REMARKS

Amendments to the Drawings:

The attached replacement sheets of drawings include changes to Figs. 2B, 2C, 2D-1, 2D-2, 2D-3, 3A, 3B-1, 3B-2, 3C-1, 3C-2, 3C-3, and 3C-4 and replaces the original sheet including Figs. 2B, 2C, 2D-1, 2D-2, 2D-3, 3A, 3B-1, 3B-2, 3C-1, 3C-2, 3C-3, and 3C-4.

FIG. 2B

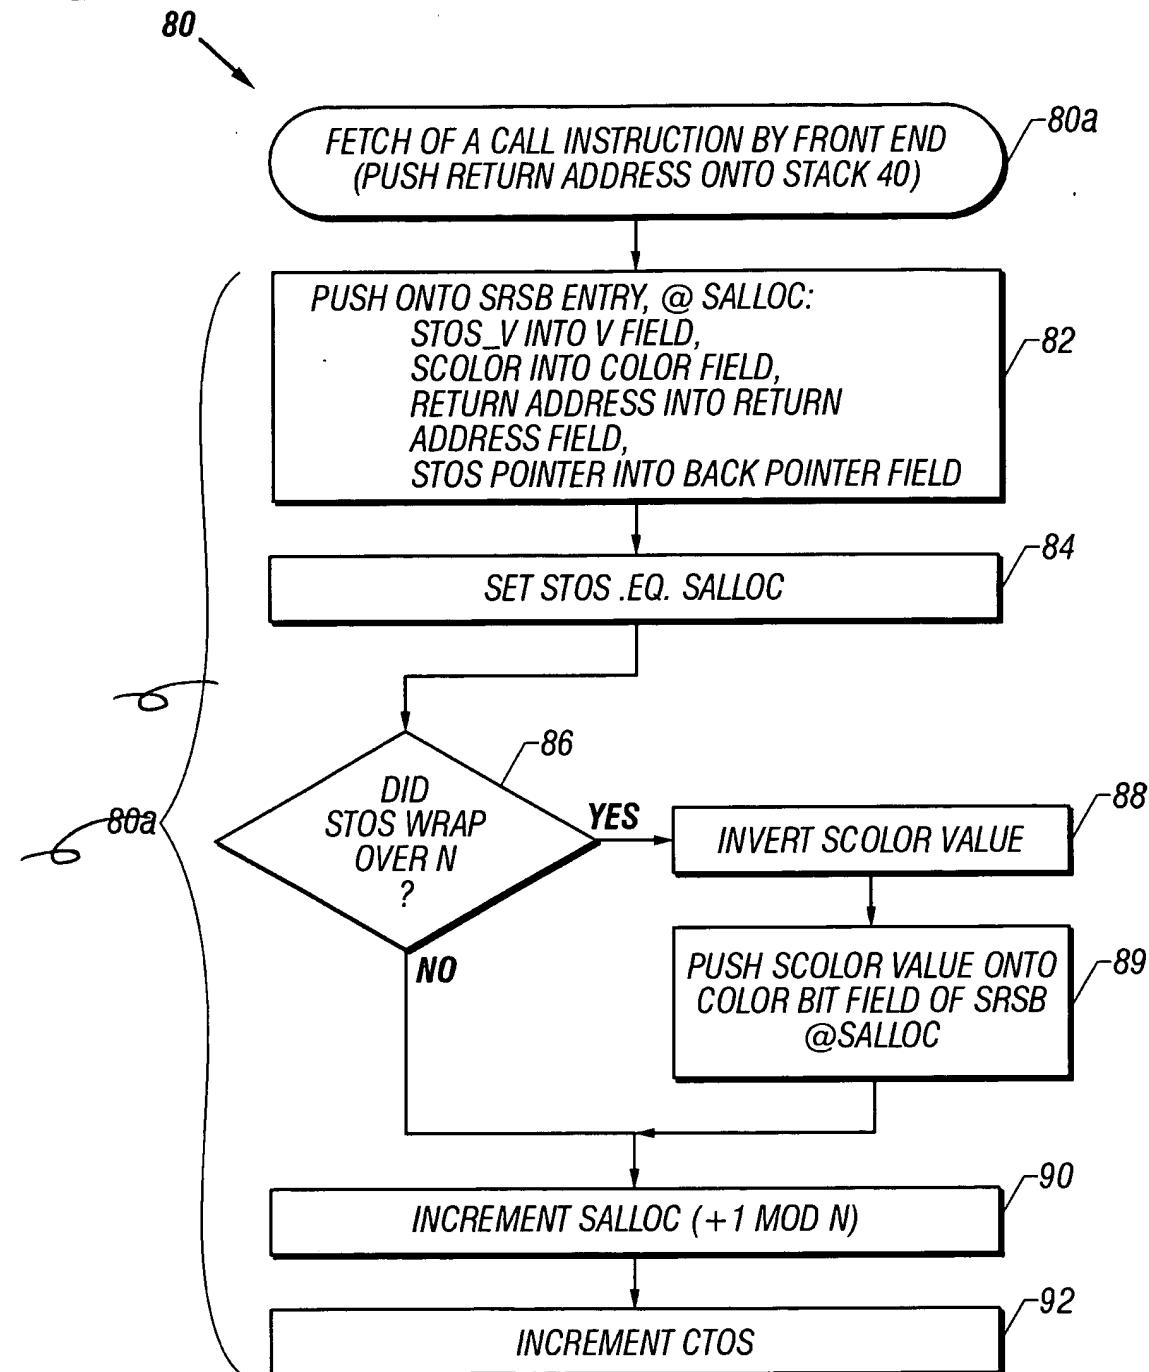
In Figure 2B, the reference 80a identifying the sequence of actions, 82-92, has been removed.

FIG. 2C

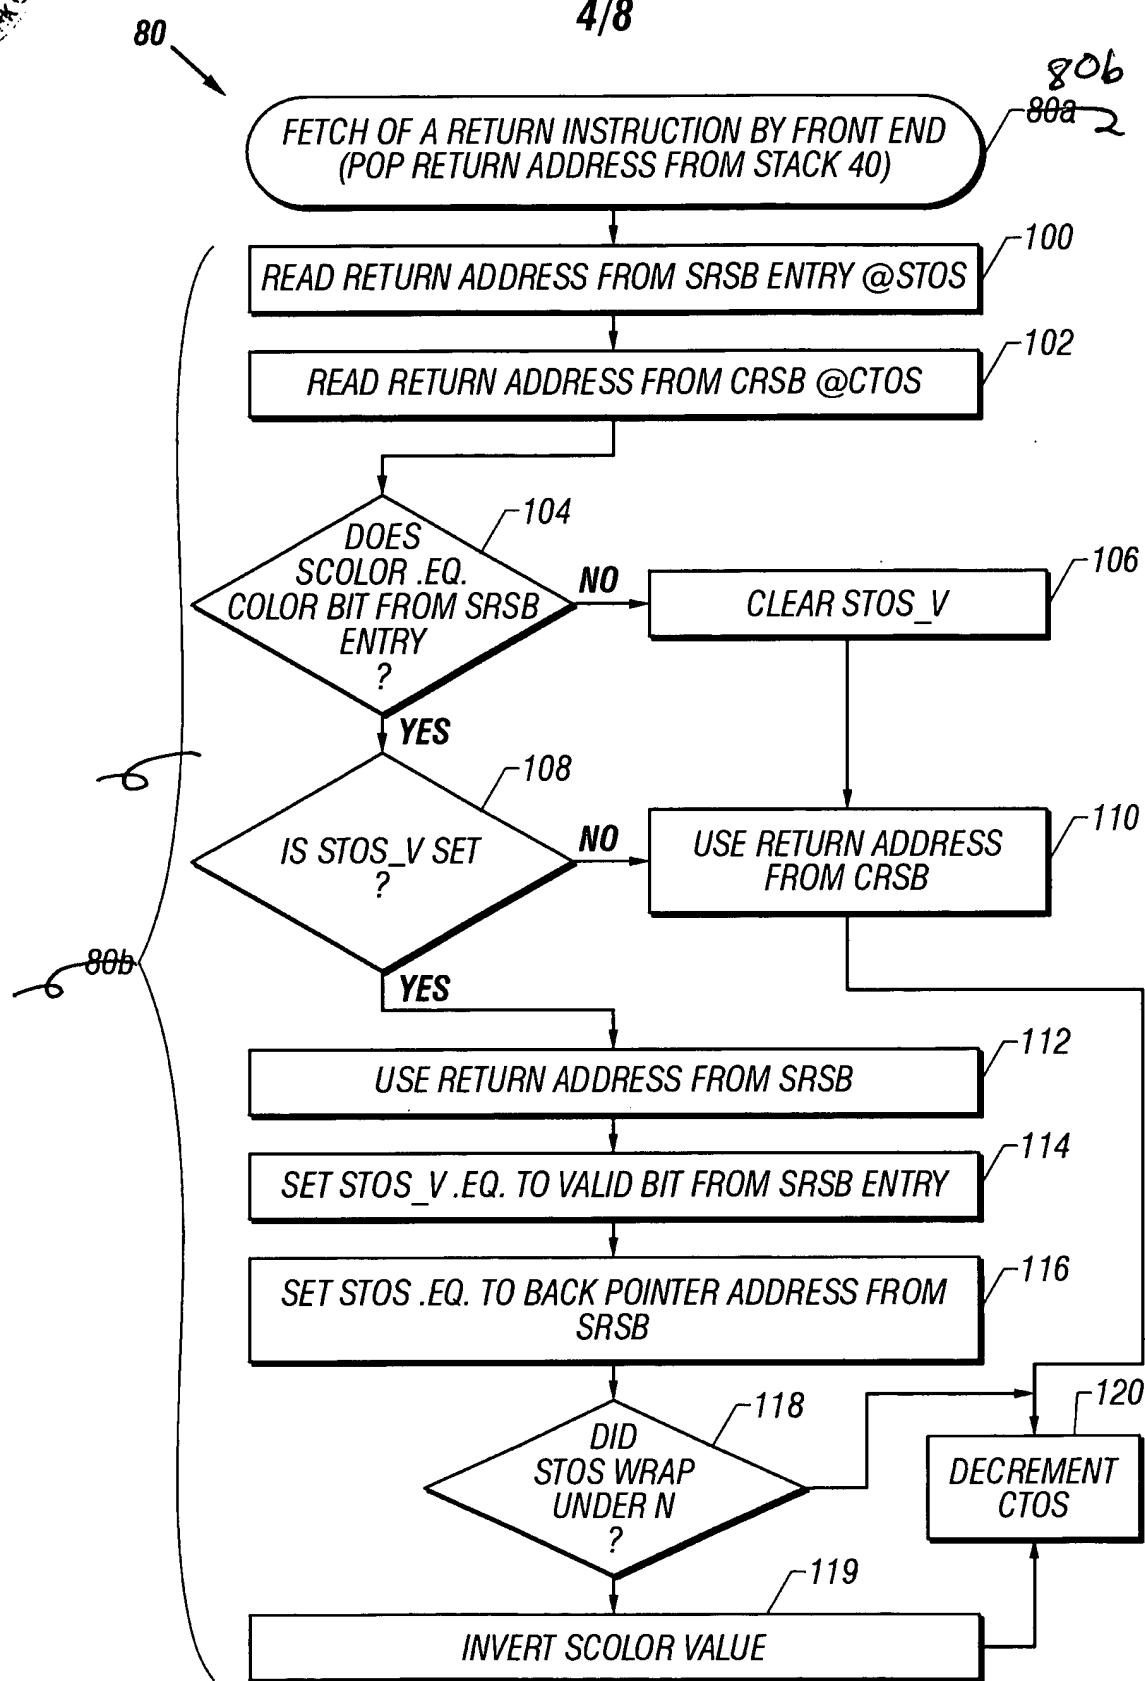
In Figure 2C, the reference 80a has been changed to 80b, and the reference 80b identifying the sequence of actions, 100-120, has been removed.

FIG. 2D-1

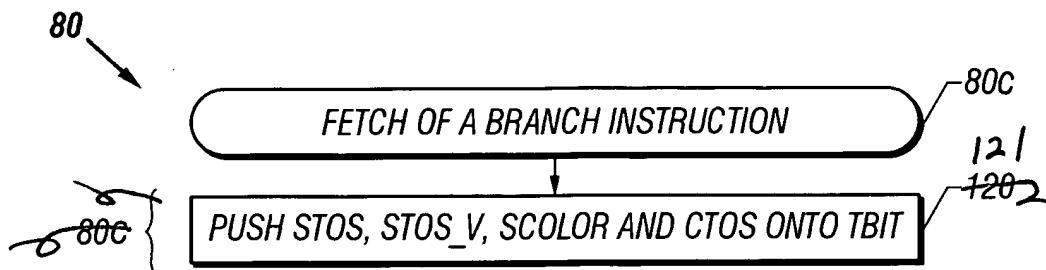
In Figure 2D-1, the reference 120 has been changed to 121, and the reference 80c identifying the action, 120 (now 121), has been removed.

In Figure 2D-1, the reference 80f has been changed to 80e, and the reference 80e identifying the sequence of actions, 126-128, has been removed.

FIG. 2D-2

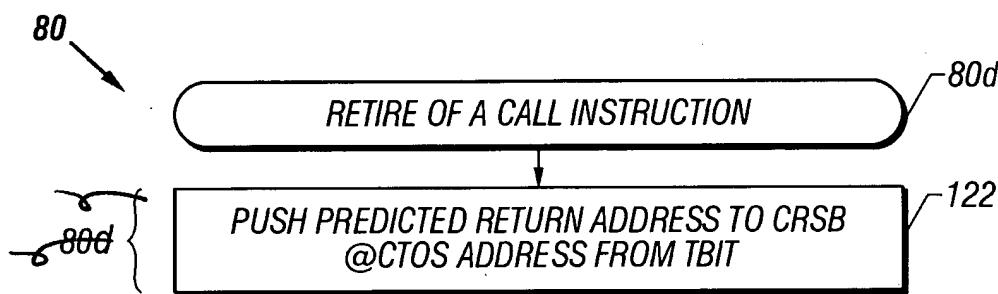
In Figure 2D-2, the reference 80d identifying the action, 122, has been removed.

FIG. 3A

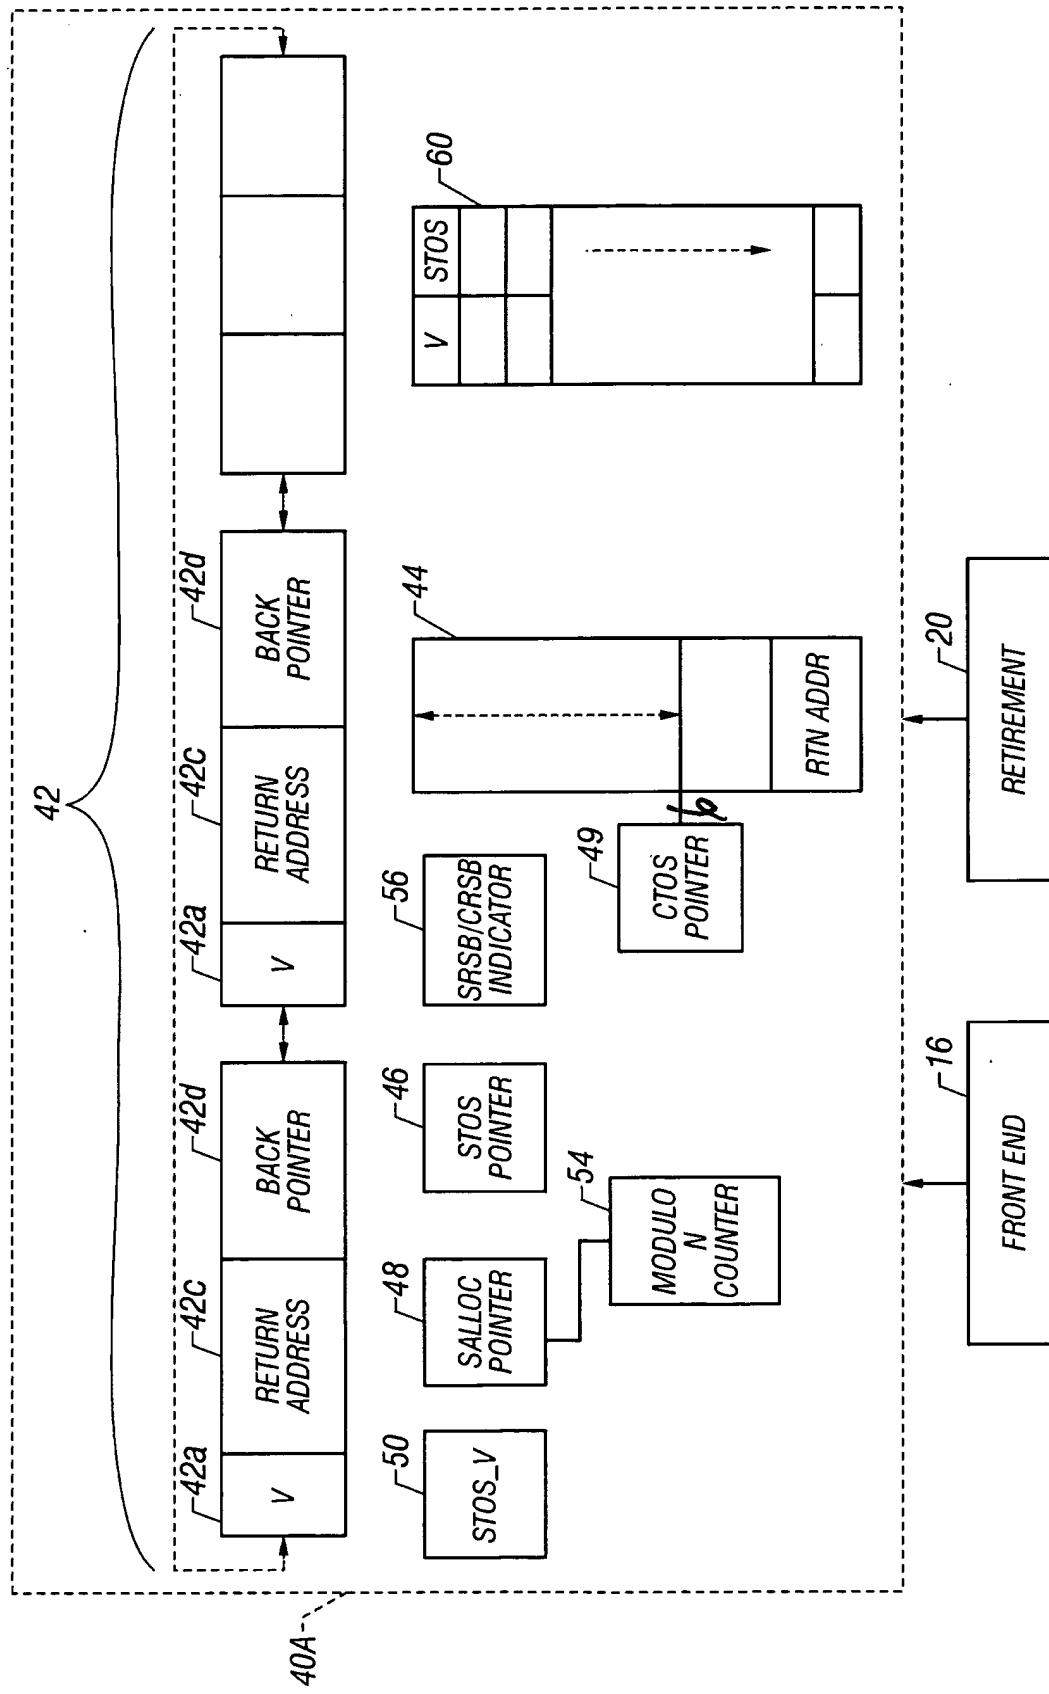
In Figure 3A, an extra line connecting the CTOS pointer 49 and the CRSB 44 has been removed.

FIG. 3B-1

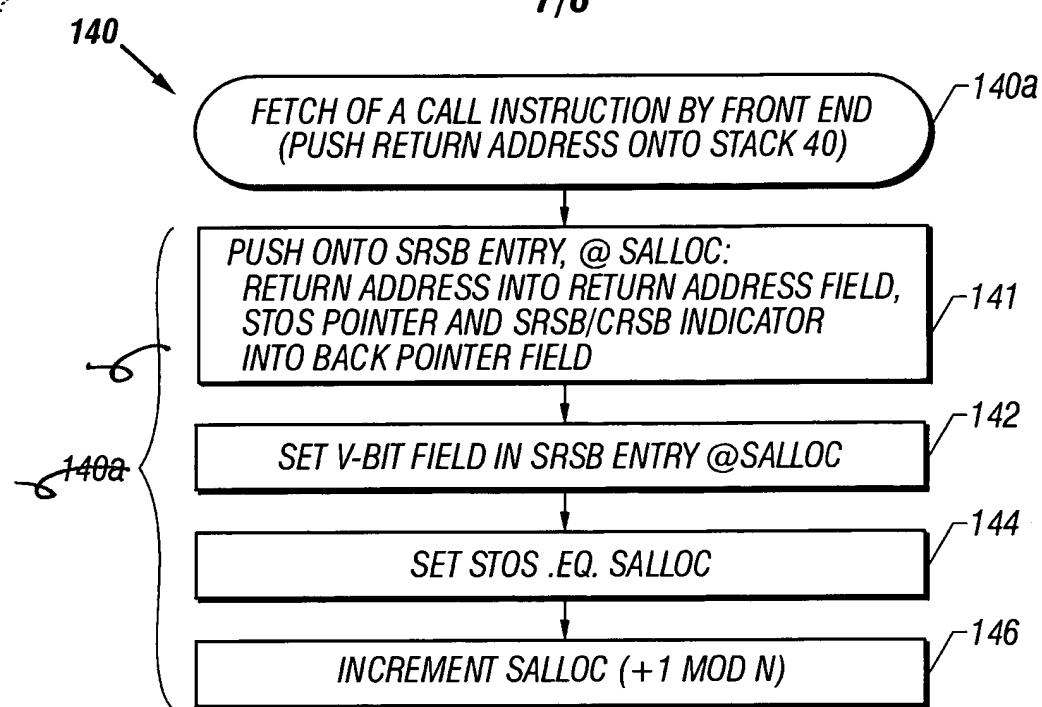
In Figure 3B-1, the reference 140a identifying the sequence of actions, 141-146, has been removed.

FIG. 3B-2

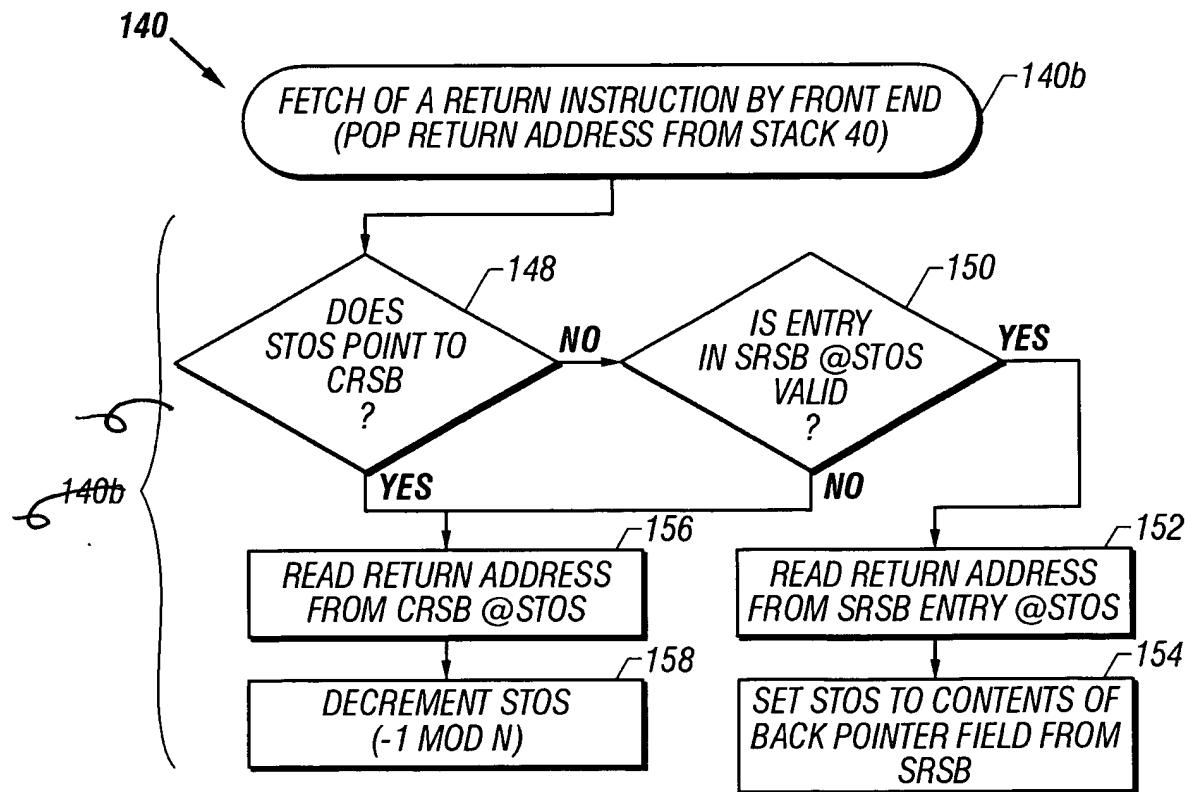
In Figure 3B-2, the reference 140b identifying the sequence of actions, 148-158, has been removed.

FIG. 3C-1

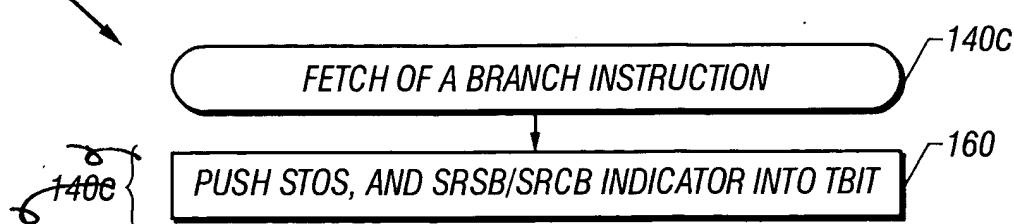
In Figure 3C-1, the reference 140c identifying the action, 160, has been removed.

FIG. 3C-2

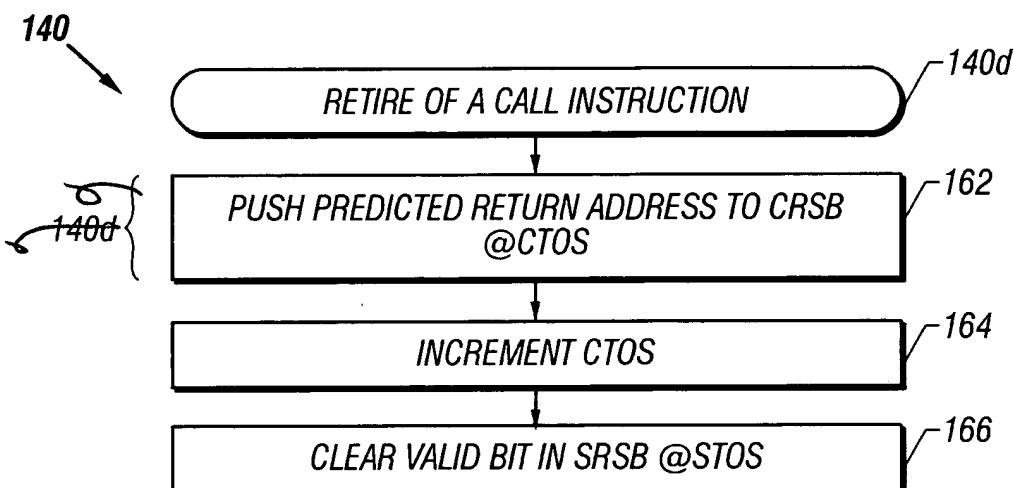
In Figure 3C-2, the reference 140d identifying the action, 162, has been removed.

FIG. 3C-3

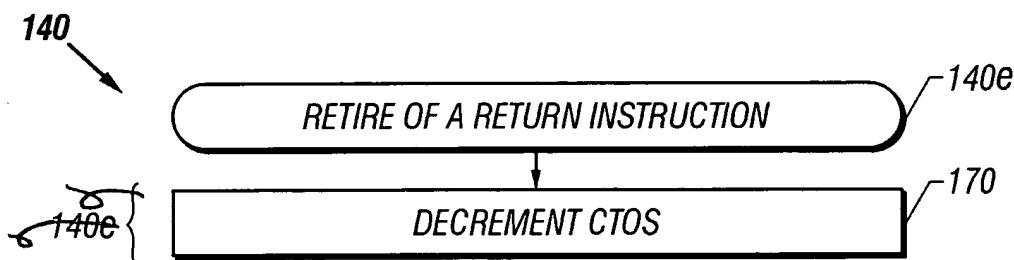
In Figure 3C-3, the reference 140e identifying the action, 170, has been removed.

FIG. 3C-4

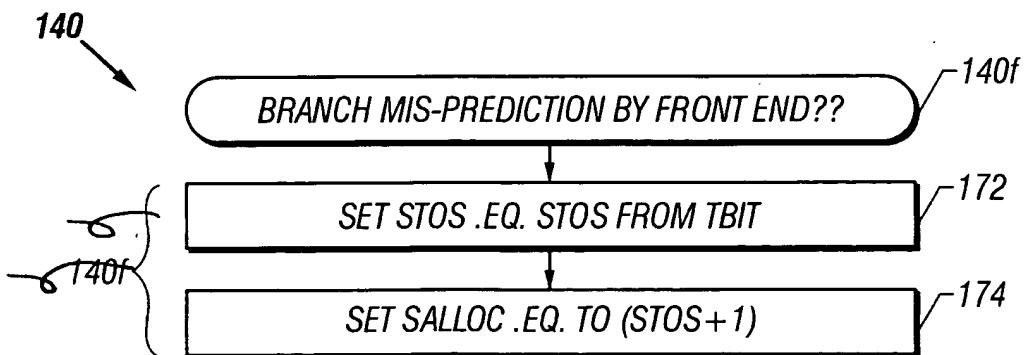
In Figure 3C-4, the reference 140f identifying the sequence of actions, 172-174, has been removed.
